#### Re: Georgia Power Company – Plant Branch Proposed CCR Landfill – Site Acceptability Review Comments APL 1579

Enclosed please find Georgia Power Company's (GPC) response to comments on the Site Acceptability Report (SAR) submitted for the proposed Plant Branch CCR Landfill. The comments were received in a letter dated October 23, 2019, which were generated by EPD's review of the Site Acceptability Report prepared by Geosyntec. Following are each of the comments from the EPD and a written response.

Response to SAR Comments – Proposed CCR Landfill Georgia Power – Plant Branch – Putnam County, Georgia Georgia Environmental Protection Division January 2020

### PLANT BRANCH LANDFILL GEOLOGIC CROSS-SECTIONS

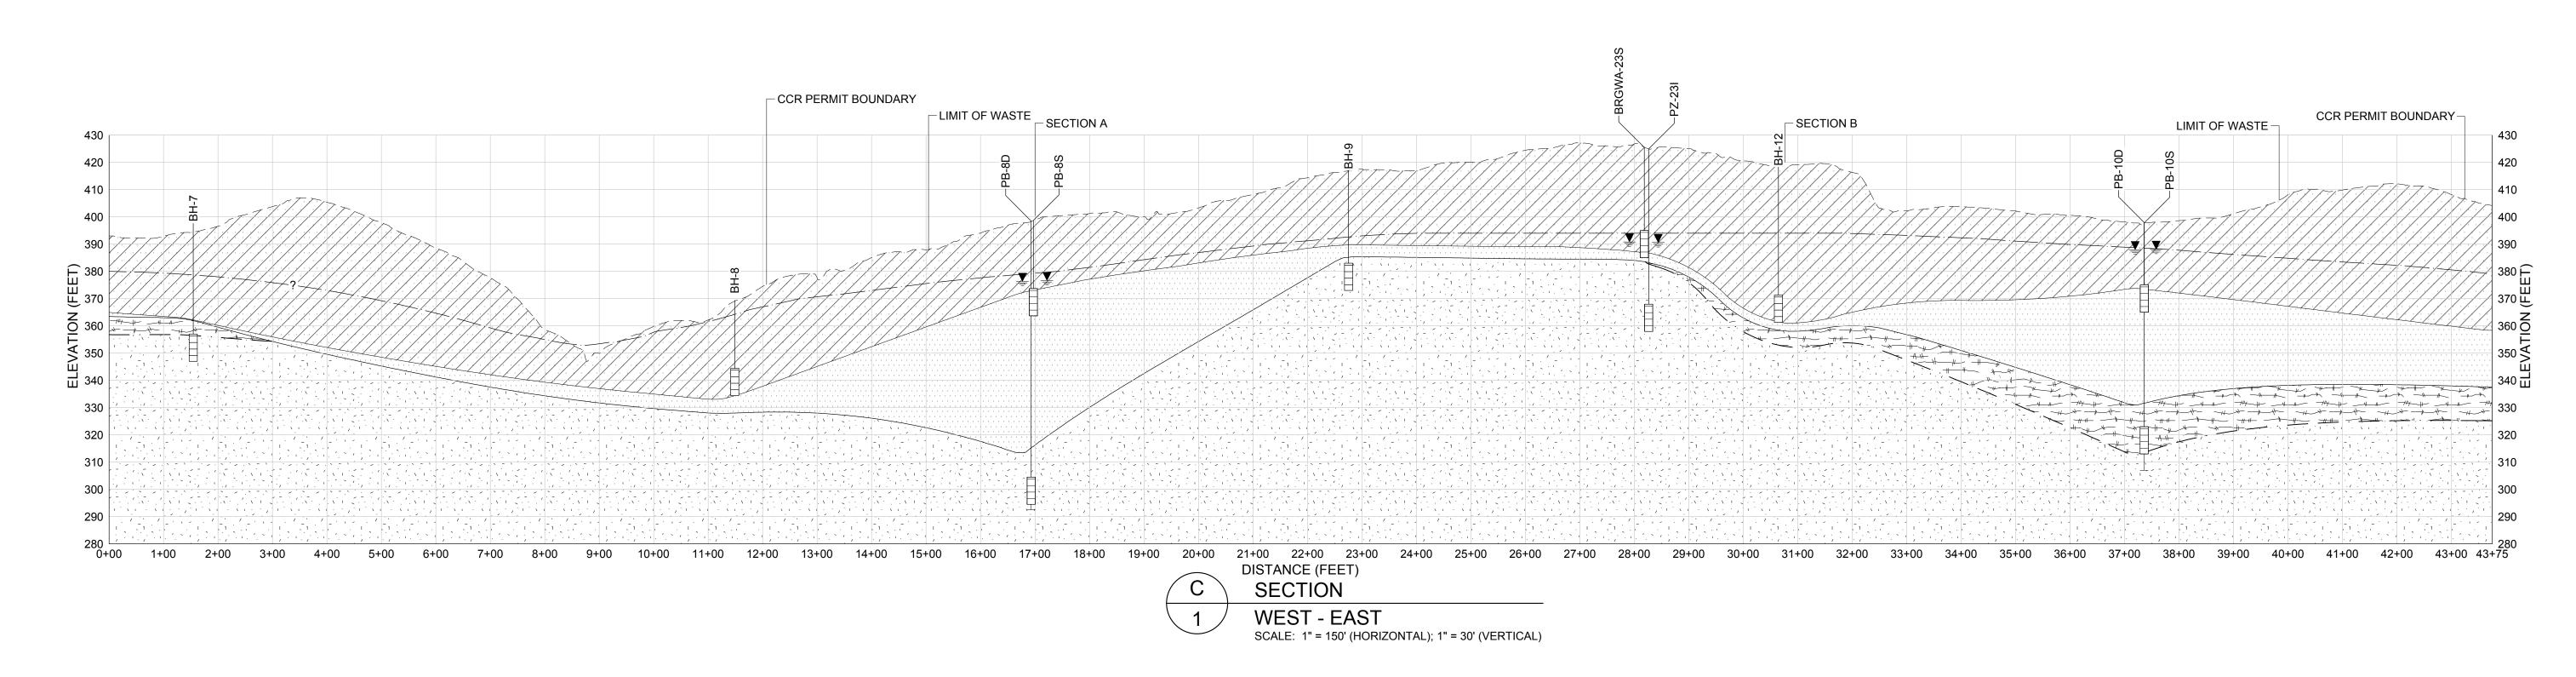
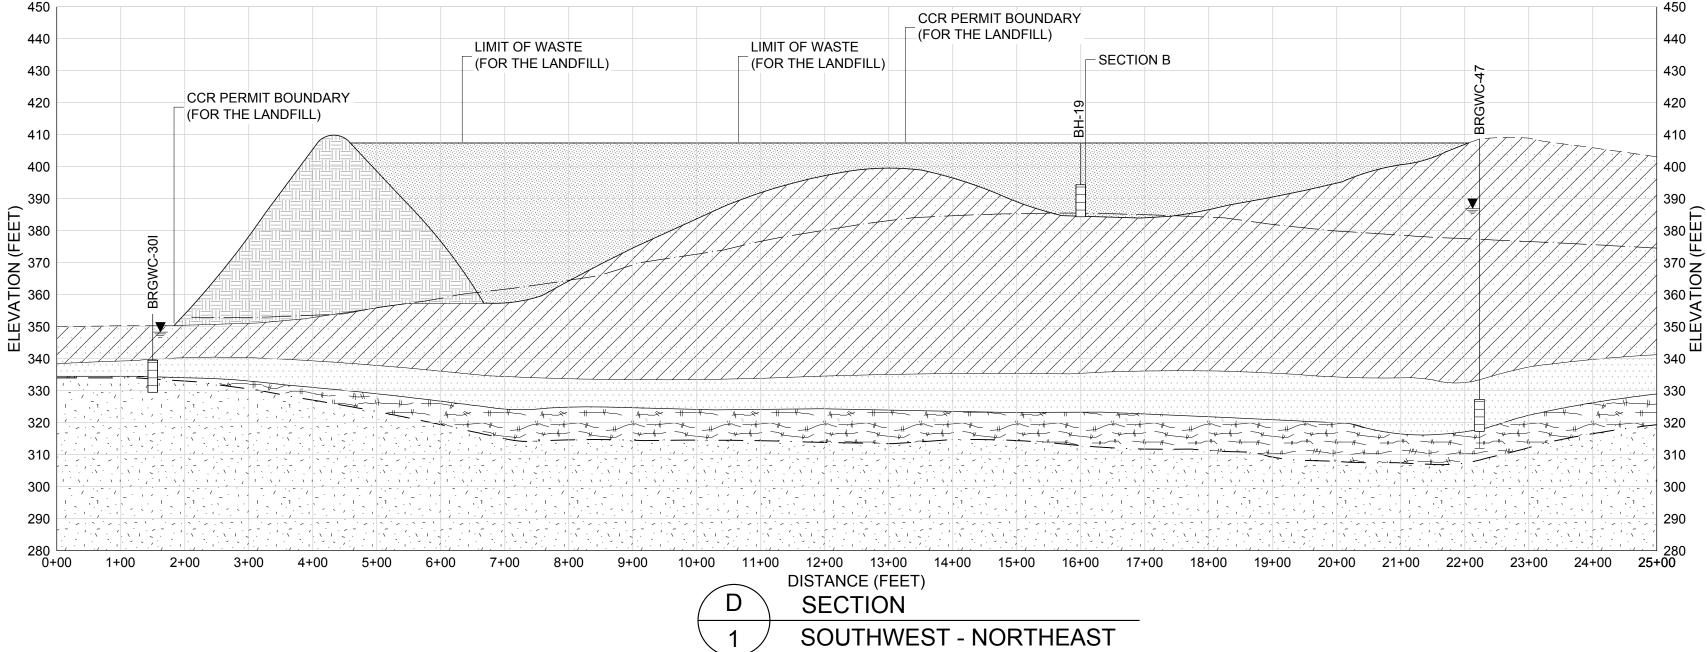
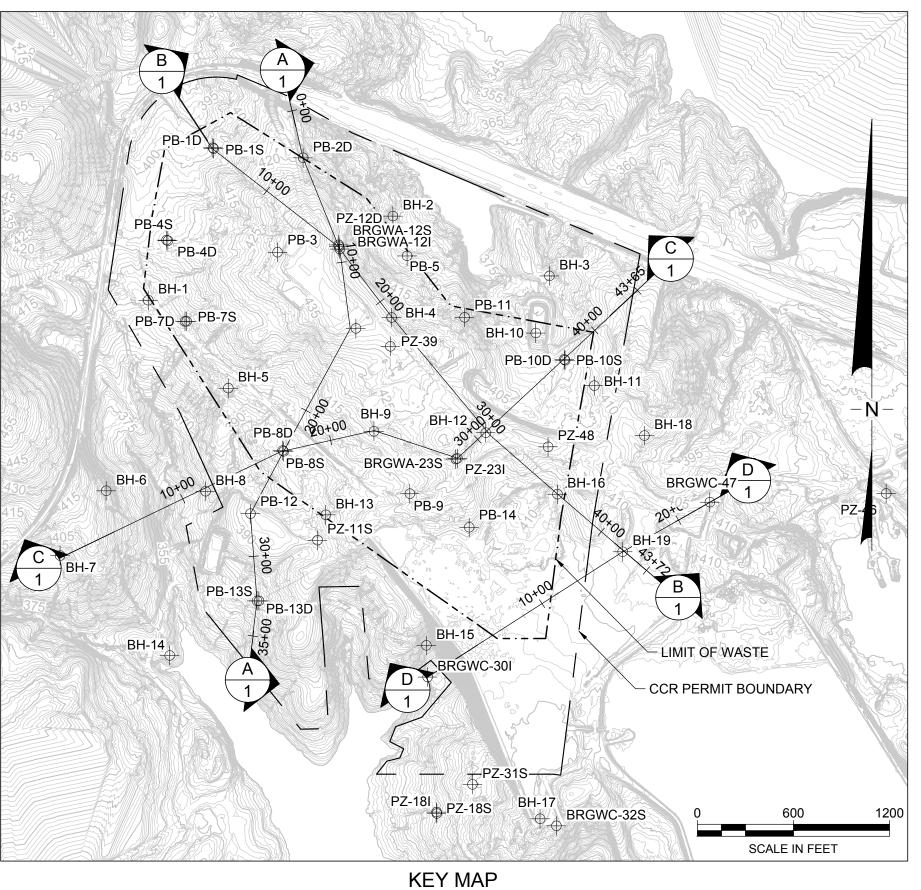
- Cross-sections B and C show BH-12 encountering Gneiss bedrock. This is not consistent with the drilling log for BH-12 included in Appendix D.
- According to the drilling log, BH-19 encountered ash to total depth.
- Cross-section B should be revised to show Ash Pond D.
- Cross-section B shows a deep well completion at PB-1D that is not consistent with the drilling log included in Appendix D.

<u>Comment No. 3:</u> An additional geologic cross-section should be constructed that transects Ash Pond D. EPD suggests that this cross-section include BRGWC-47, BH-19, and BRGWC-30I and show the original topography beneath the ash pond.

**Response:** The items noted above (bullets 1 to 5) have been addressed and the requested revisions to existing cross-section B, as well as Figures 2-7 and 3-1 have been made. The revised cross-sections and figures are included in Attachment B.

**Response:** The additional cross-section (cross-section D) has been prepared and is included in Attachment B.
